BEFORE THE NEW PLYMOUTH DISTRICT COUNCIL

IN THE MATTER of PC18/00049 being a request under section 73(2) of the Act by **HAREB INVESTMENTS LIMITED** to the **NEW PLYMOUTH DISTRICT COUNCIL** for a Private Plan Change to rezone 2 Johnston Street, Waitara from Rural (FUD) to Residential A and Open Space.

**STATEMENT OF EVIDENCE MICHAEL DAVID MATANGI ON BEHALF OF
HAREB INVESTMENTS LIMITED**

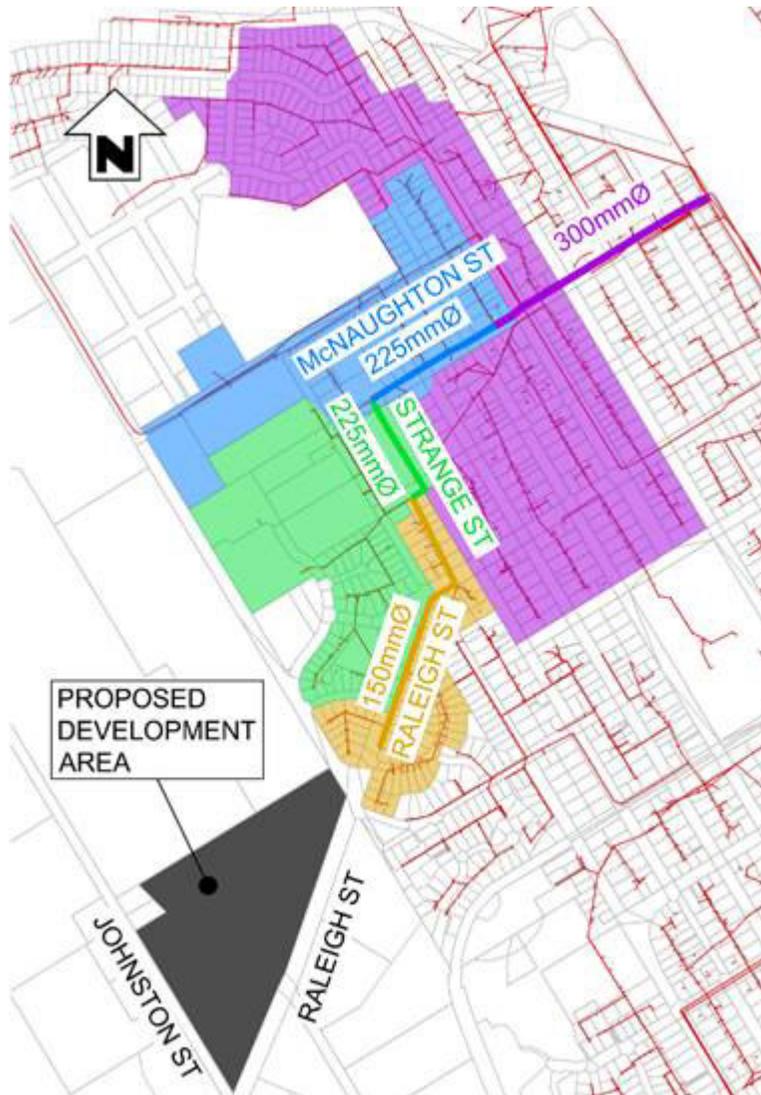
With regard to the capacity of the 300mm dia sewer pipe on McNaughton St, I began creating a SSA model, and added the catchment that contributes to the 300mm dia sewer main on McNaughton St.

In calculating the catchment to add to the 300 dia sewer main (the purple shaded area above), I decided to begin with the previously adopted conservative approach of assuming:

The values highlighted in blue above show the maximum developed PWWF for the existing developed and proposed development area at 43.7 L/s, with the capacity of the critical portion of the 300mm dia sewer pipe of 55 L/s. In conclusion, I believe this demonstrates with the most conservative of approaches to calculating the sewer capacity, there is adequate capacity in the gravity sewer main to the pump station.

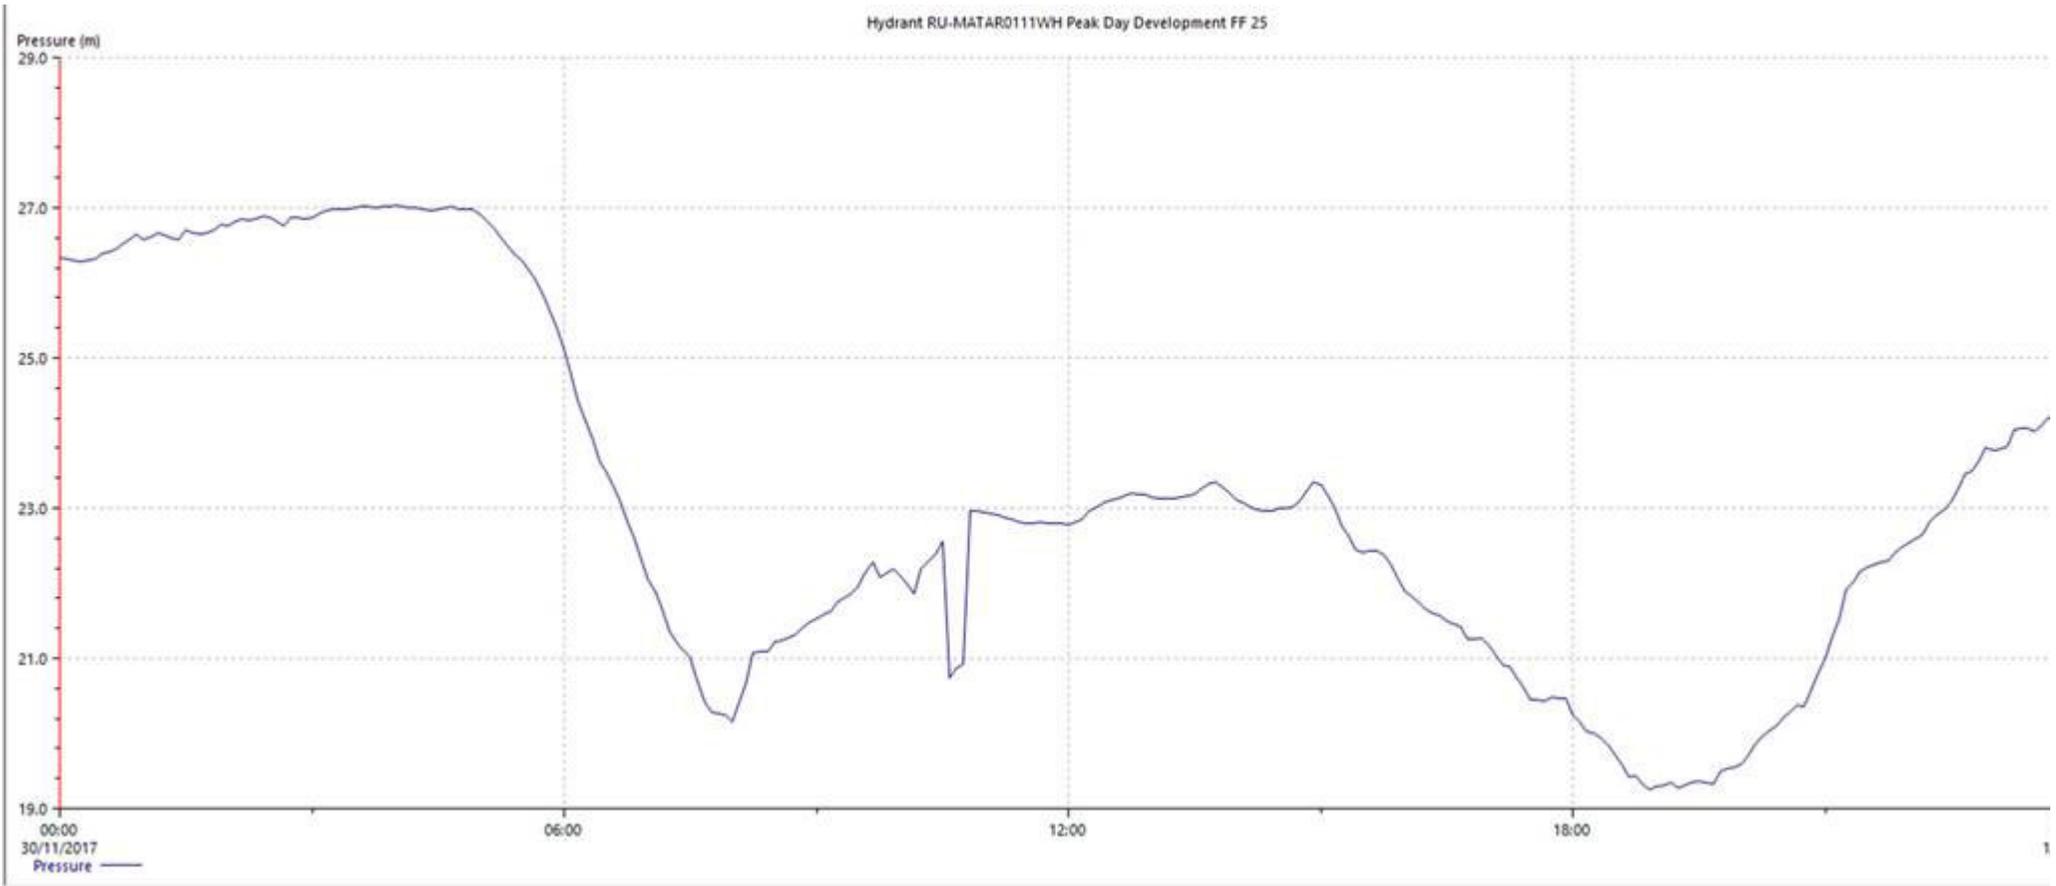
In the 25 l/s FF scenario (fighting fire at Raleigh Street Development) the lowest pressure occurs at node RU-MATAR0111WE. This is along Matarikoriko Rd, outside the township proper, but still in the Waitara Pressure Zone. As you will see below, the low pressure is actually a result of evening demand, and not the fire flow demand at around 10:30am

Therefore, we believe there is adequate pressure for firefighting for FW2 (and in reality FW3) for the higher elevation land at the proposed development.

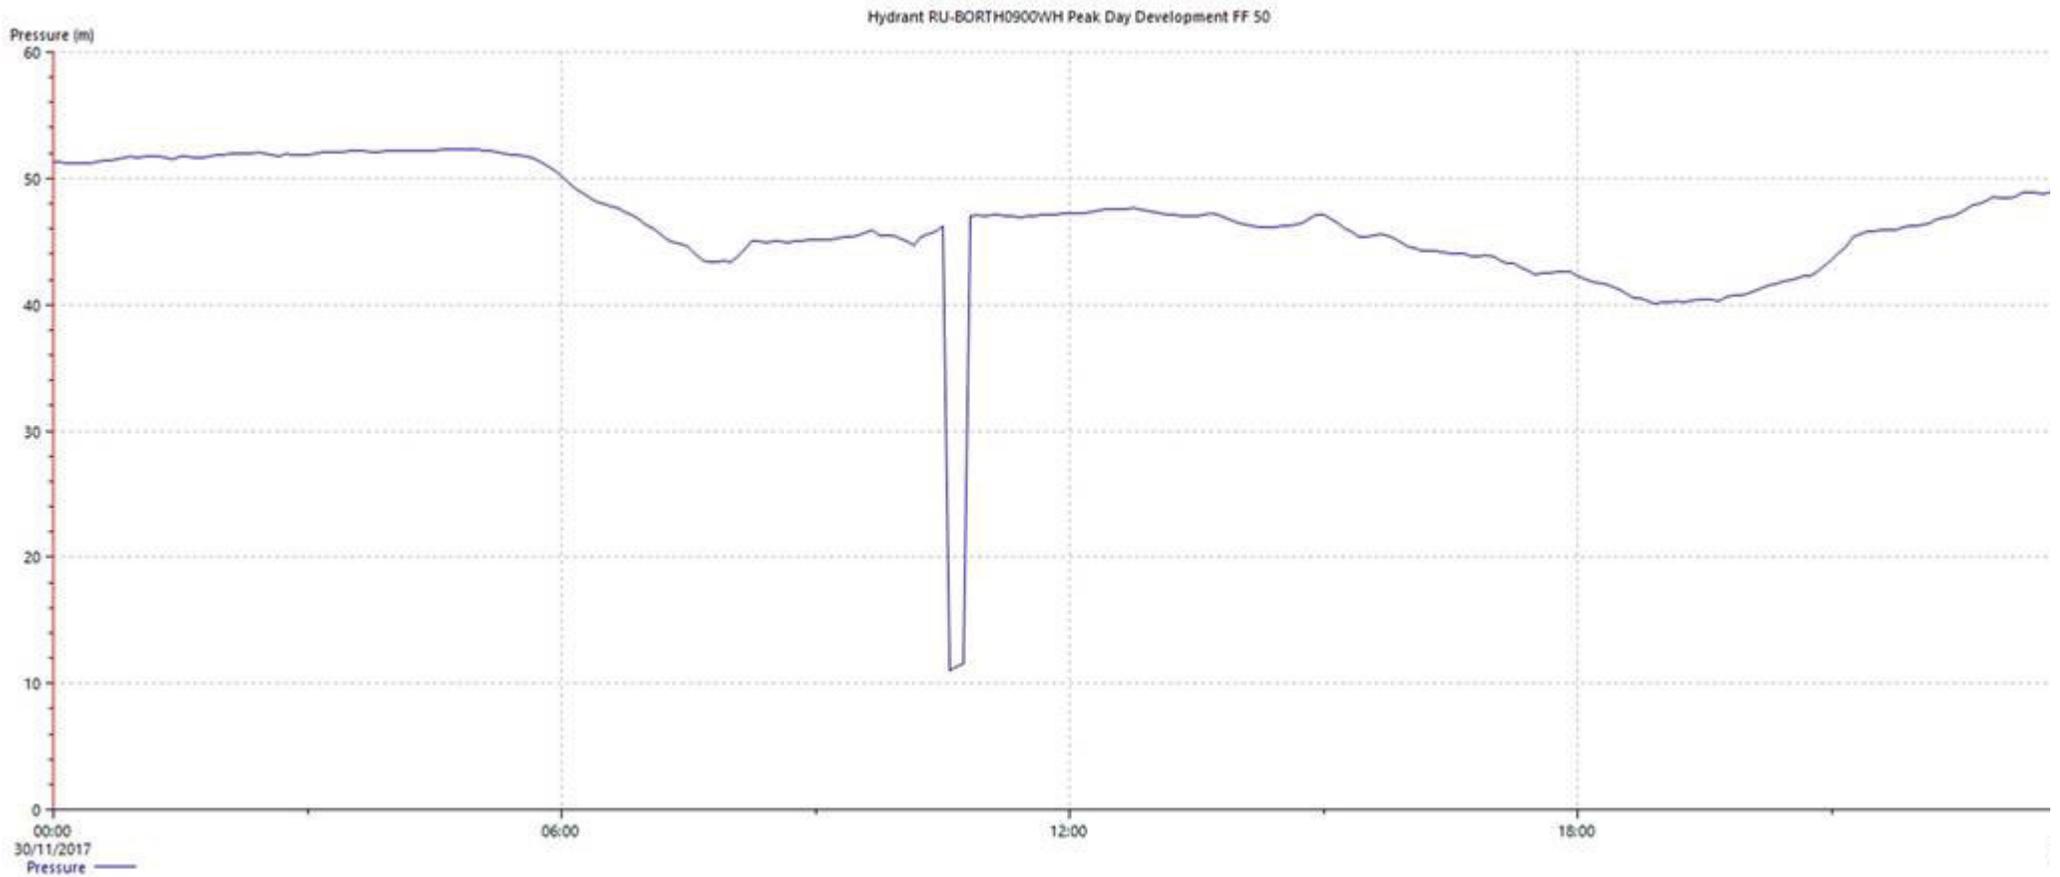
In the 50 l/s scenario node RU-BORTH0900WE records the lowest pressure. This is very close to the development, but has a slightly higher elevation – therefore results in a lower pressure, as shown below.

The model runs indicate that 9 hydrants in the zone fail to provide 12.5 l/s while maintain greater than 10m pressure. The addition of the Raleigh Street Development demands doesn't change this number (i.e. remains at 9). The addition of the Raleigh Street Development demands does however reduce the available flow at hydrants by an average of 1.6 l/s, and a maximum of 4.5 l/s (RU-WAIT10053WH) which is located close to the site.
